SONIC
RESTAURANT

STAFF REPORT

RE: **2312 & 2318 N. Roosevelt Blvd
(permit application # T17-8629)**

FROM: Karen DeMaria, City of Key West Urban Forestry Manager

TYPICAL EASEMENT AREA
(Refer to Engineering Plans for Specific Easement Designations)

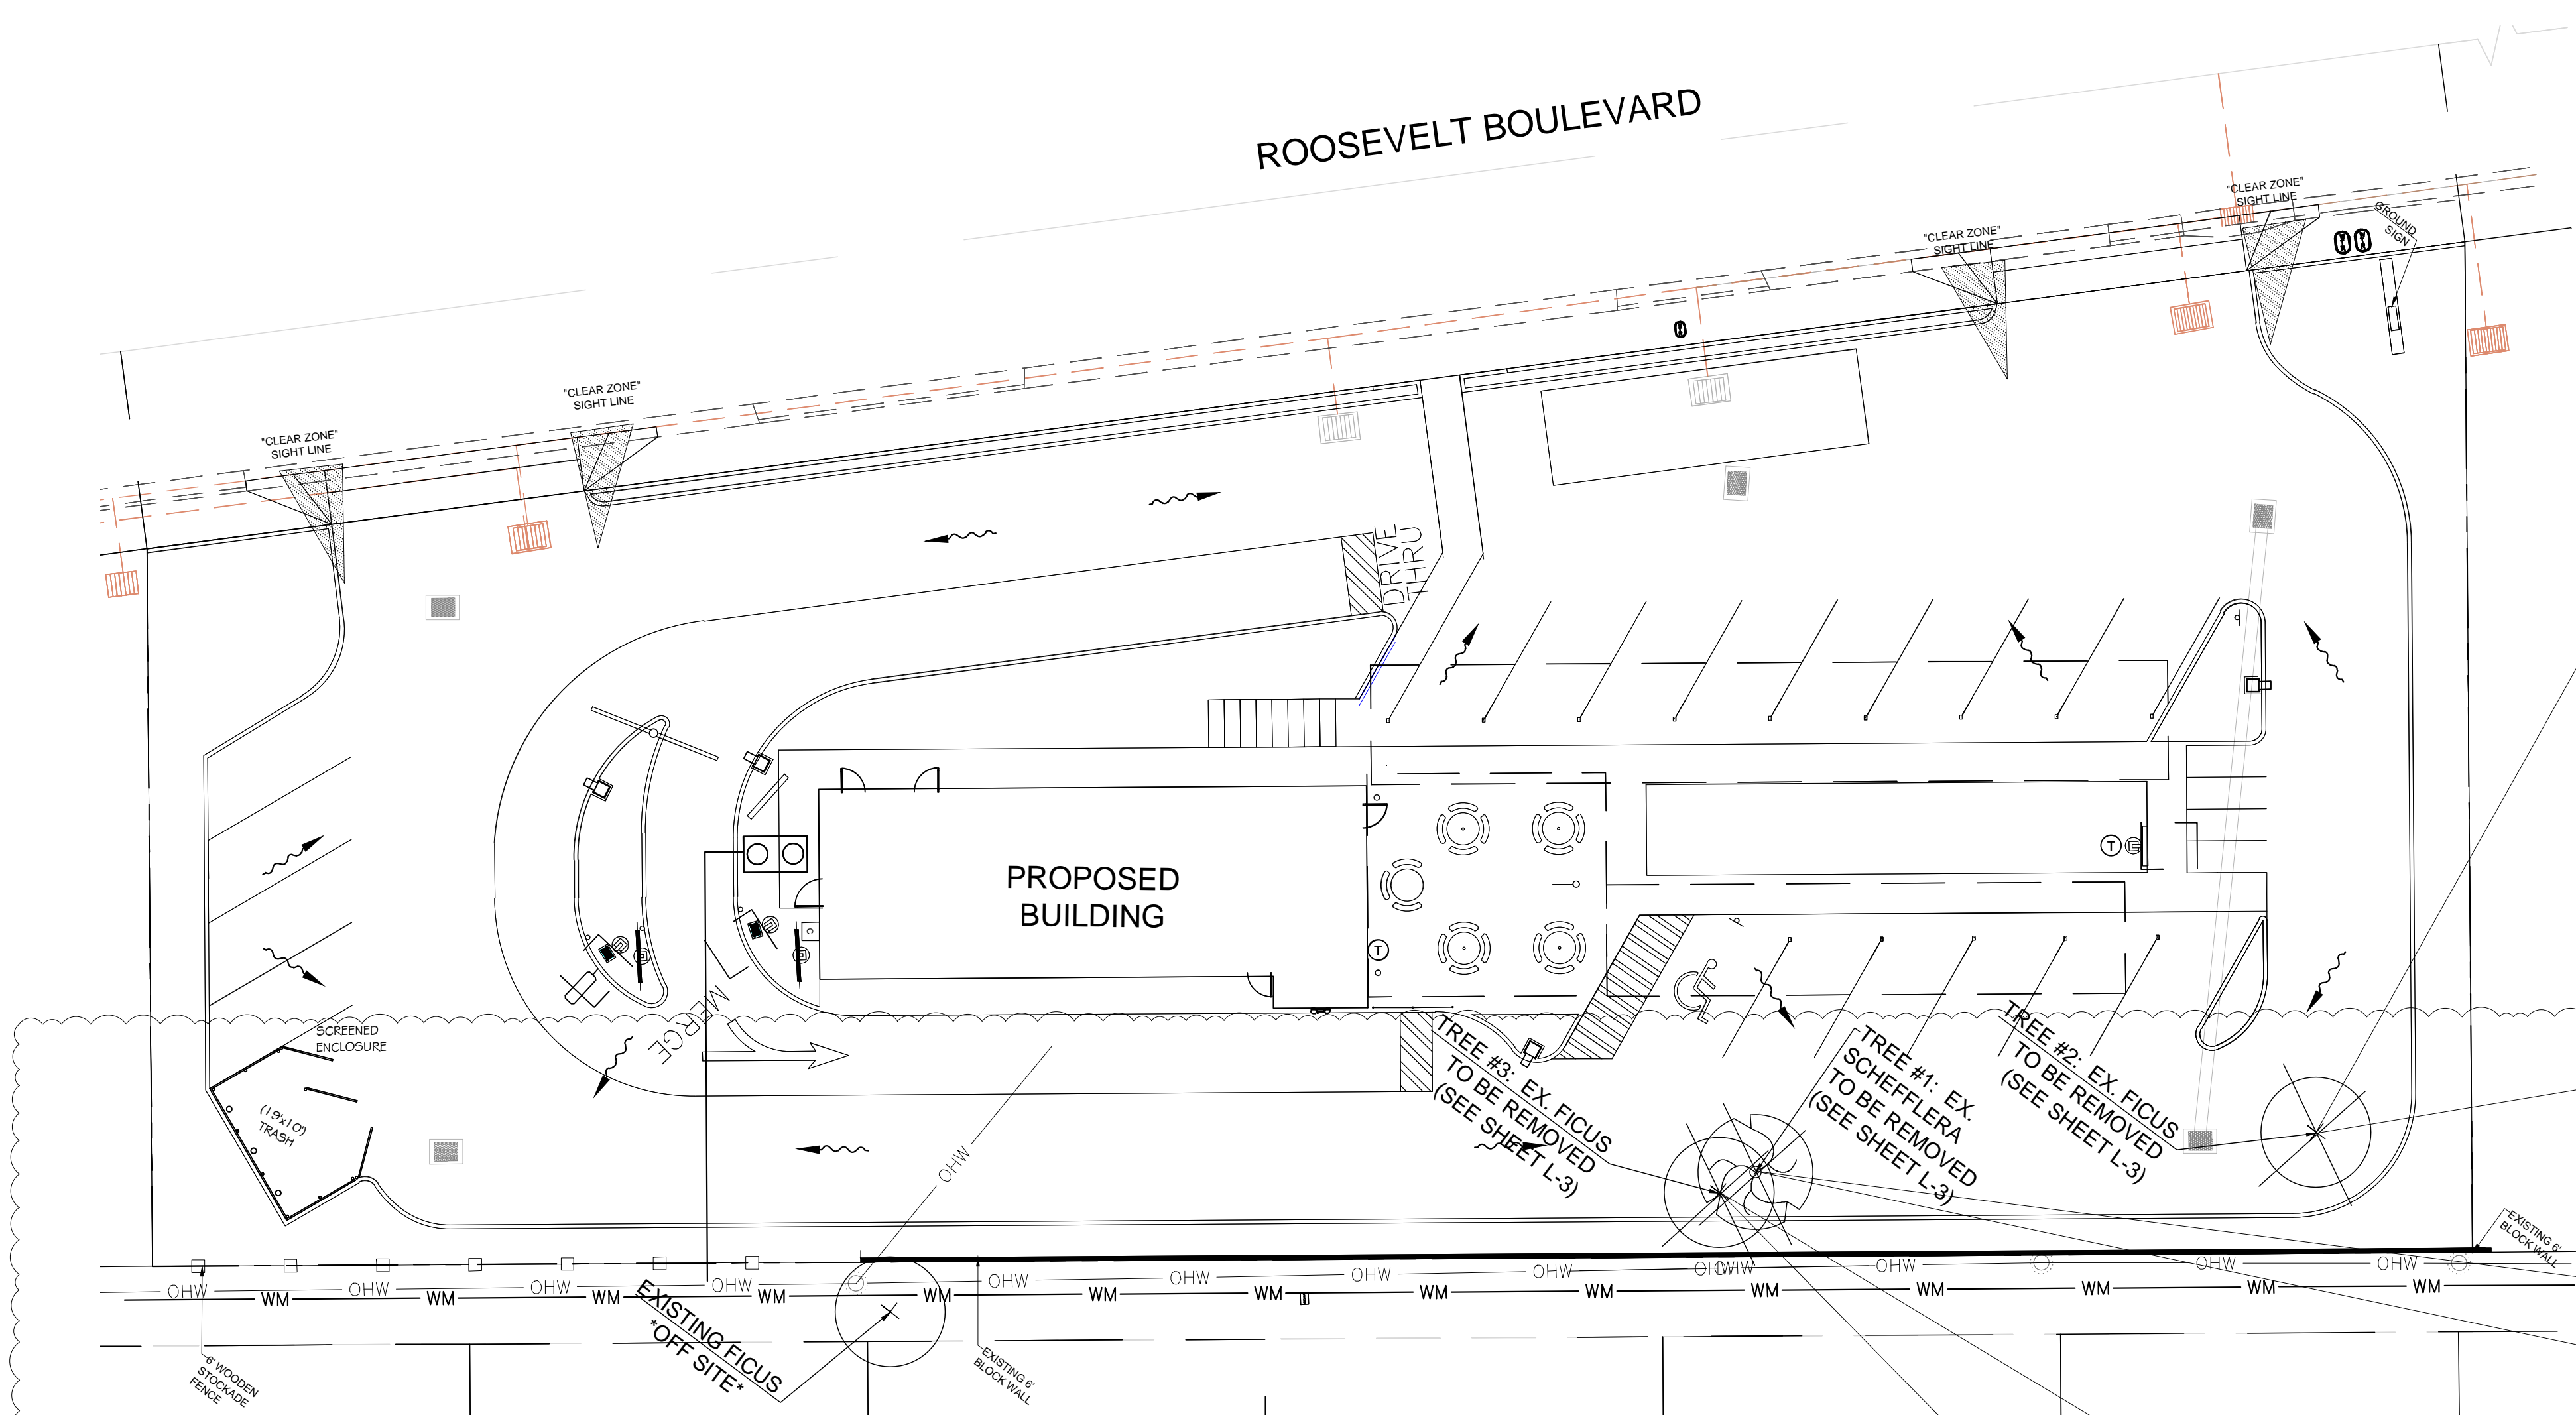
The Final Landscape Plan submitted does incorporate all the required tree removal replacements (46.3 caliper inches) and is over 70% native vegetation.

The proposed landscape plan appears to incorporate all the required replacement inches and is over 70% native and salt tolerant vegetation.

Recommendation: Recommend approval of the Final Landscape Plan with Tree Removal to include the removal of (2) Strangler Fig trees at 2318 N. Roosevelt Blvd. The approval requires the replacement of 46.3 caliper inches of native dicot and/or fruit trees from the approved list, FL#1, to be planted onsite and incorporated into the landscape plan.

SHEET TITLE:
TREE REMOVAL
PLAN

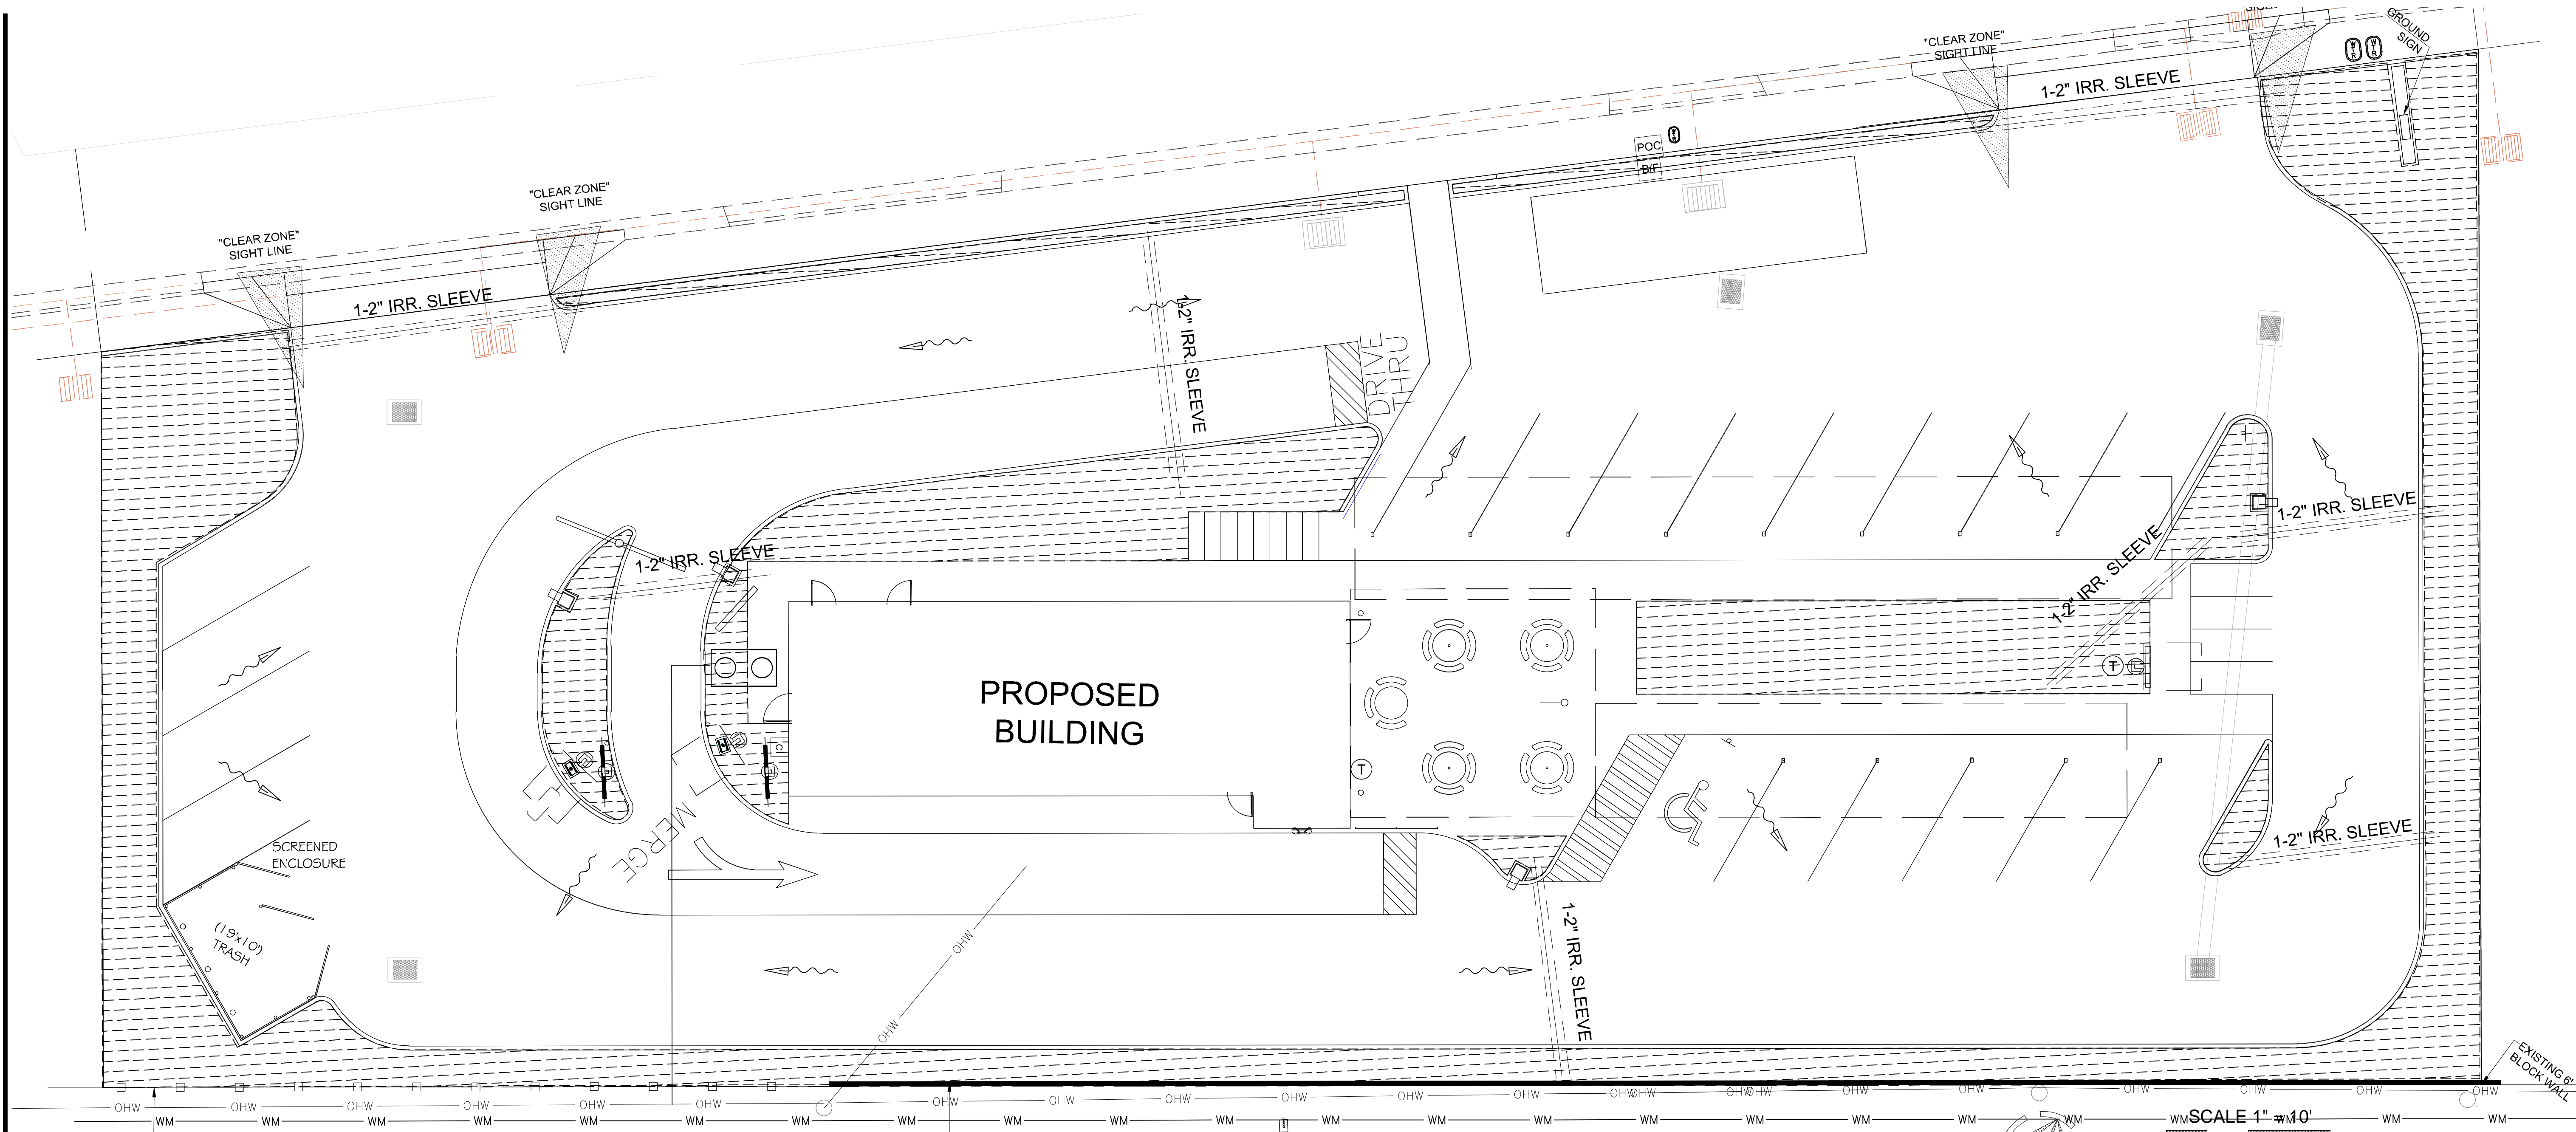
An application was received requesting the removal of **(2) Strangler Fig trees**. The request is in association with a Minor Development Plan to build a Sonic Restaurant at a previously developed commercial property. A site inspection was done on June 14, 2017 and documented the following:

Both Strangler Fig trees to be removed are located in the rear of 2318 N. Roosevelt Blvd. Tree Species: Strangler Fig (*Ficus aurea*)

Tree#3: Growing behind and in Schefflera tree (no permit required to remove Schefflera tree)

Diameter: 11"

Location: 40% (part of Schefflera tree, very close to structure)

Species: 100% (on protected tree list)

Condition: 30% (very poor structure)

Total Average Value = 56%

Value x Diameter = 6.1 replacement caliper inches

Diameter: 61"

Location: 60% (close to structure)

Species: 100% (on protected tree list)

Condition: 40% (poor, lots of decay throughout tree)

Total Average Value = 66%

Value x Diameter = 40.2 replacement caliper inches

Recommendation: Recommend approval of the Conceptual Landscape Plan to include the approval to remove (2) Strangler Fig trees at 2312 & 2318 N. Roosevelt Blvd to be replaced with 46.3 caliper inches of dicot trees from approved list, FL#1, to be planted on site, incorporated in the landscape plan.
